SEISMIC MARGINS STUDY  
J. Kovic needs to review the portions of Attachment 2  
relative to UNITED STATES geotechnical engineering

NOTE FOR: George Lear, Chief SGEB  
THRU: P. T. Kuo, Section Leader, Section B, SGEB  
FROM: Frank Rinaldi, Structural Engineer, Section B, SGEB  
SUBJECT: MEETING SUMMARY - TERA's IDCVP

Re: Docket Nos. 50-329 OM, OL and 50-330 OM, OL  
Midland Nuclear Plant - Units 1 and 2  
Independent Design and Construction Verification (IDCV) Program  
Meeting Summary

130.30 With respect to Volume II, Seismic Margin Review: Reactor Containment Building, forwarded by your letter of March 30, 1983, provide the following information:

FIGURE Q&R 130.30.2-13. OTSG Point 27 X-DIR 4% Damping

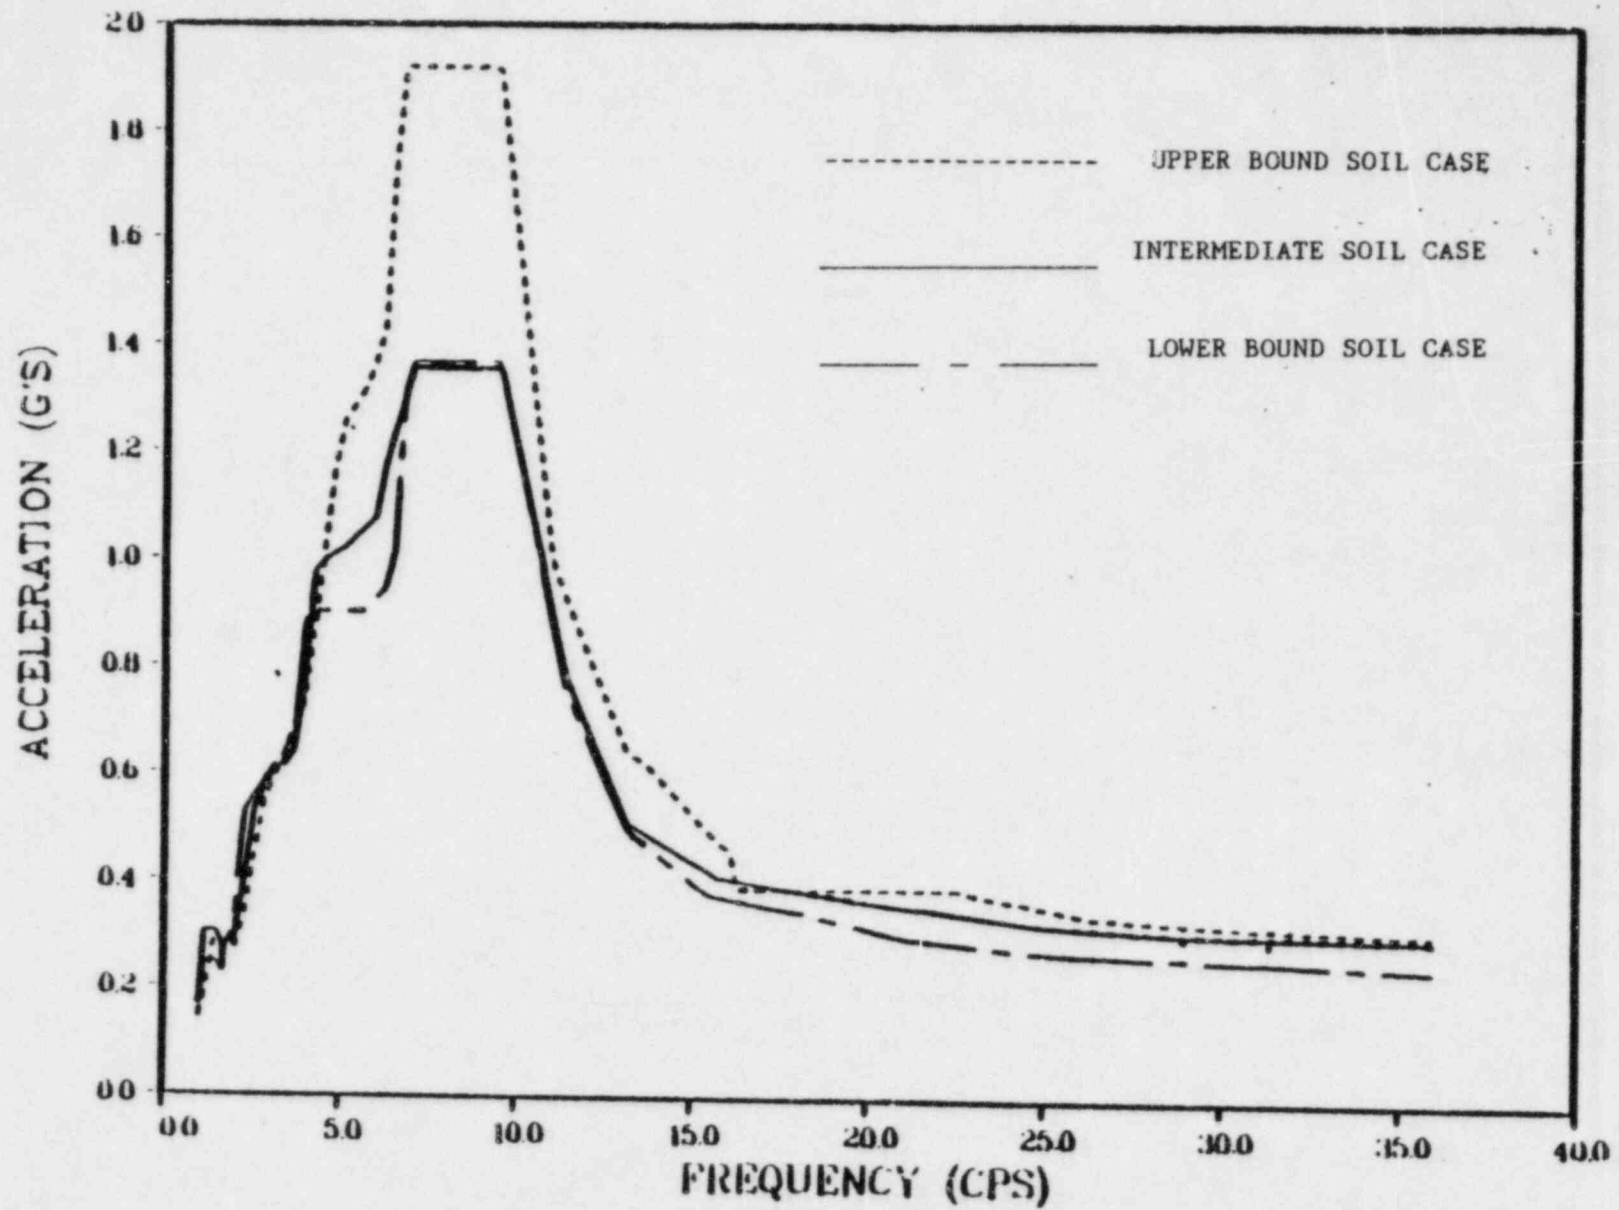
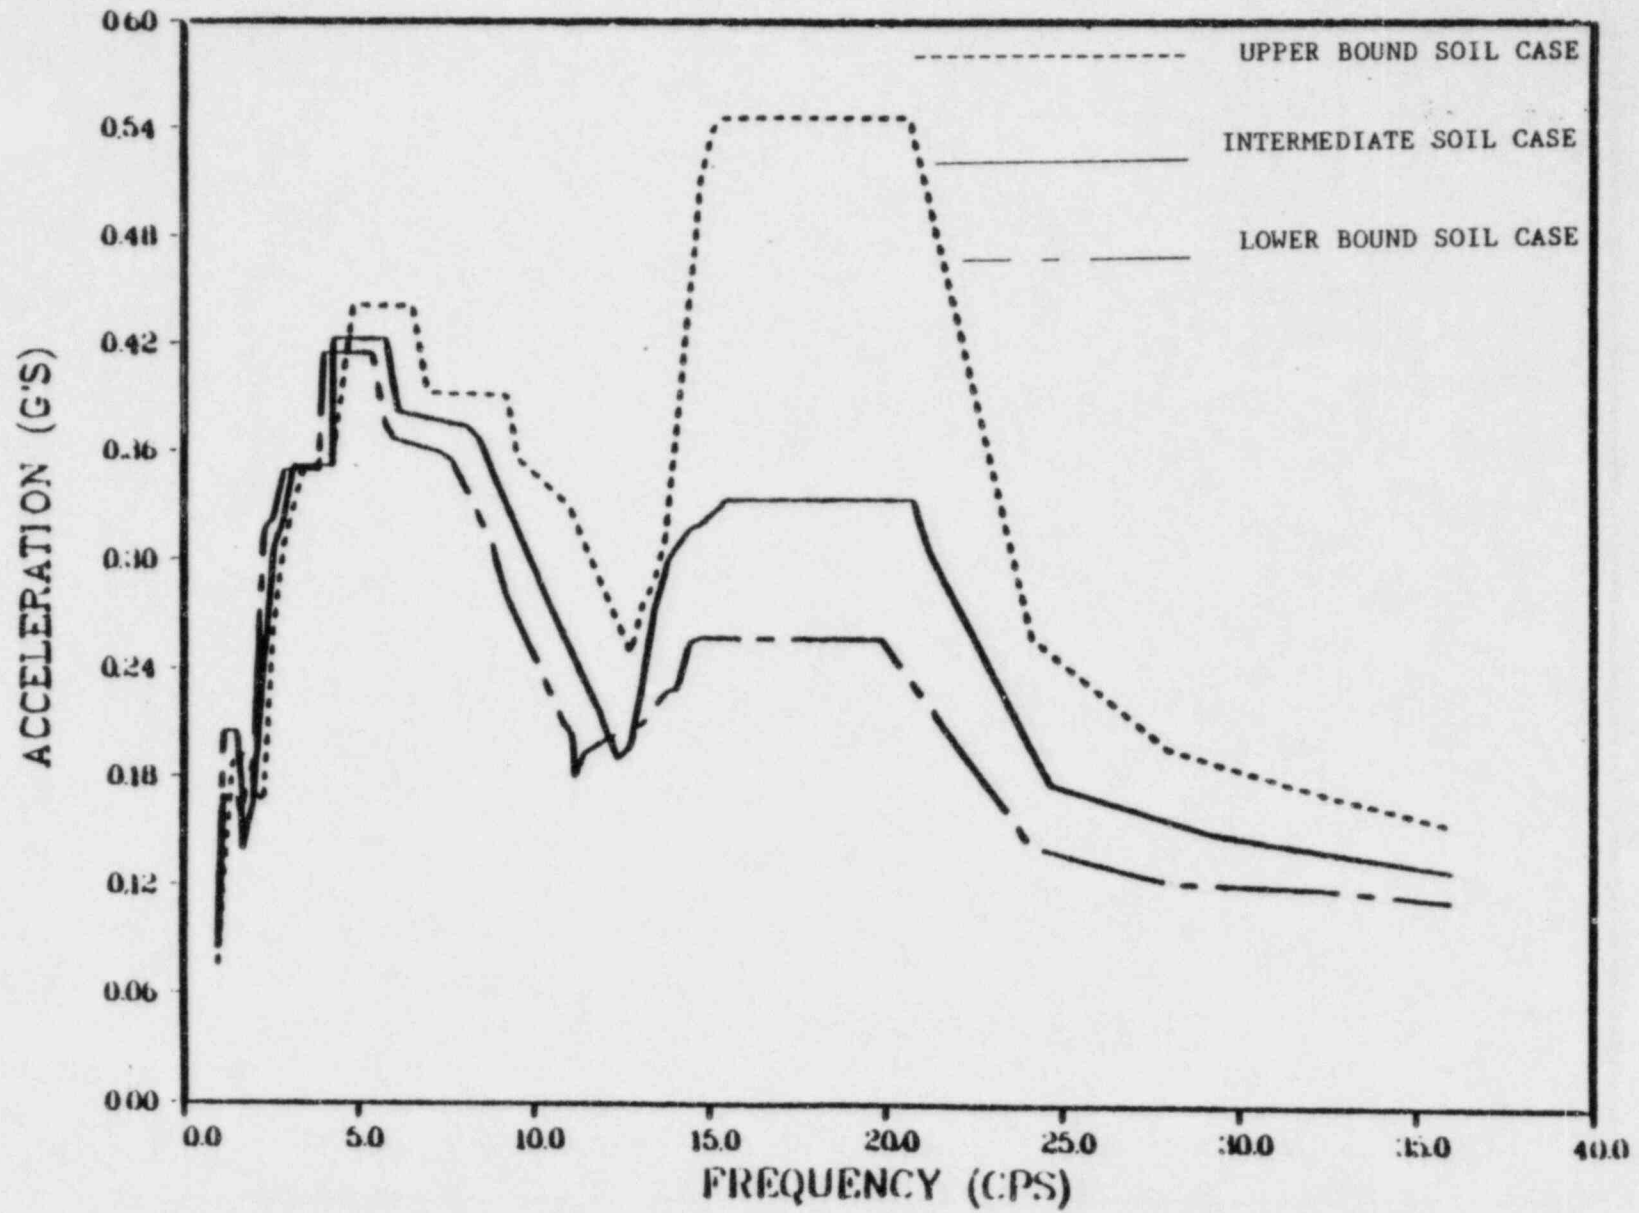
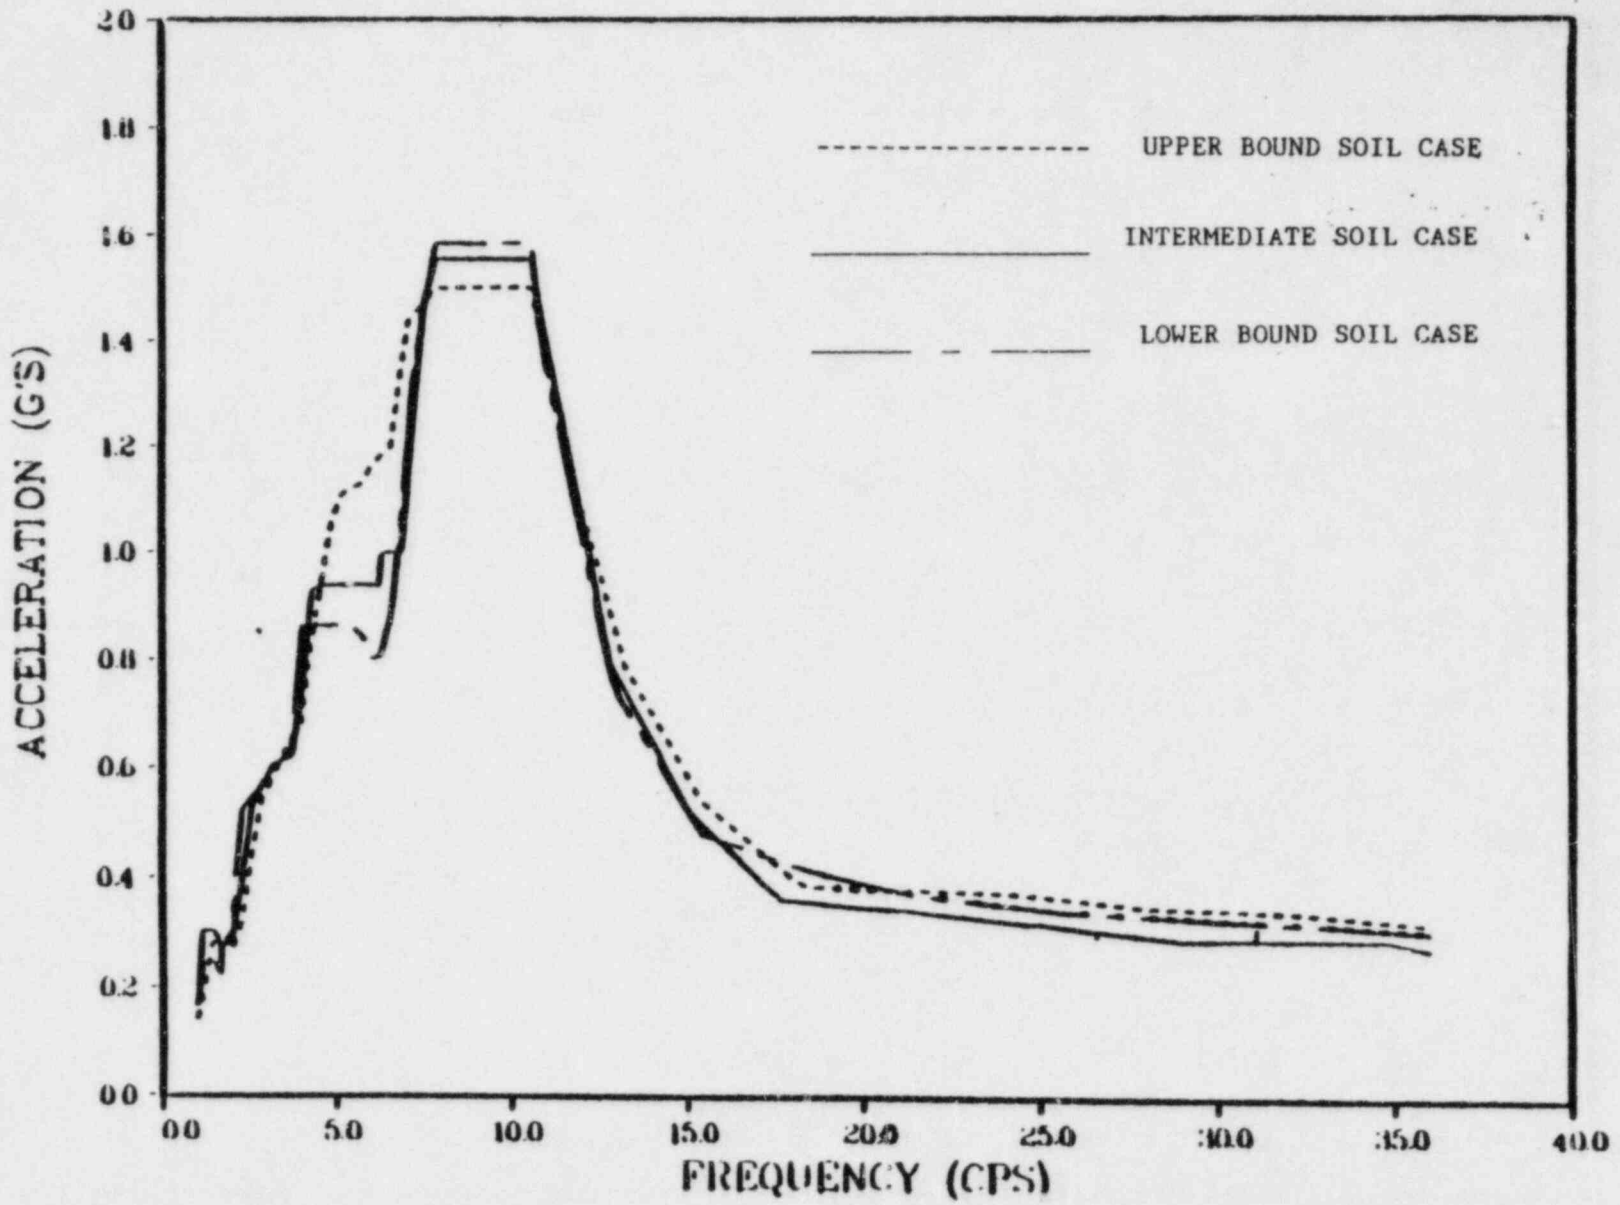
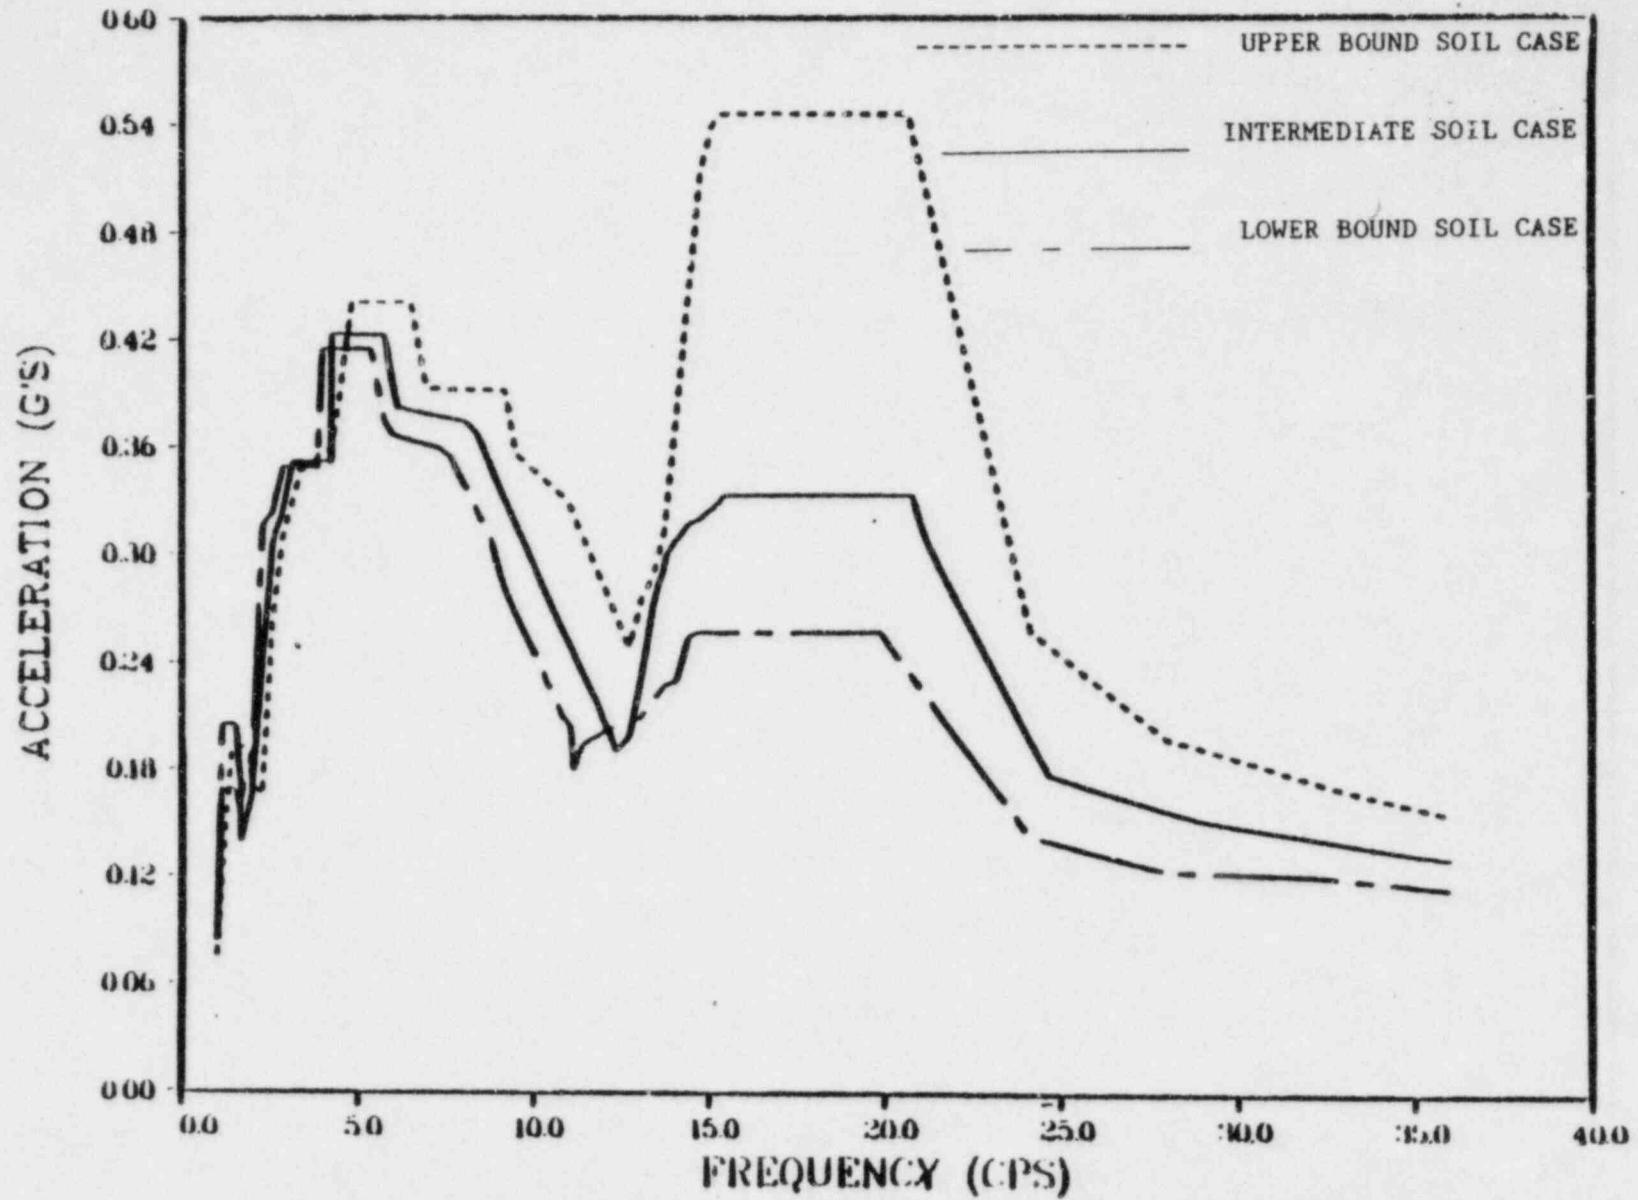
Section 5 of the report presents in-structure response spectra for internal structures. However, none are provided for the steam generators and the reactor vessel. Please provide these missing spectra or justify their omission.

Volume II was written to describe the analysis of the reactor containment buildings and their internal structures. In addition, Volume II presents the in-structure response spectra for use in evaluating equipment attached to the structure. Seismic input at the Nuclear Steam Supply System (NSSS) interfaces in the reactor containment buildings was developed by Structural Mechanics Associates, Inc. (SMA) for the Seismic Margin Earthquake. This input was defined in terms of translational and rotational time histories and response spectra for each of the three soil cases studied. The requested seismic response spectra were generated by Babcock & Wilcox (B&W), the NSSS Vendor. Since the B&W generated seismic response spectra are only an intermediate step in the Balance-of-Plant piping analysis, they were not included in Volume VIII. Figures Q&R 130.30.2-1 through Q&R 130.30.2-7 present the schematic of the reactor vessel model used by B&W and the seismic response spectra for 4 percent of critical damping. Similarly, Figures Q&R 130.30.2-8 through Q&R 130.30.2-17 are presented for the steam generators.
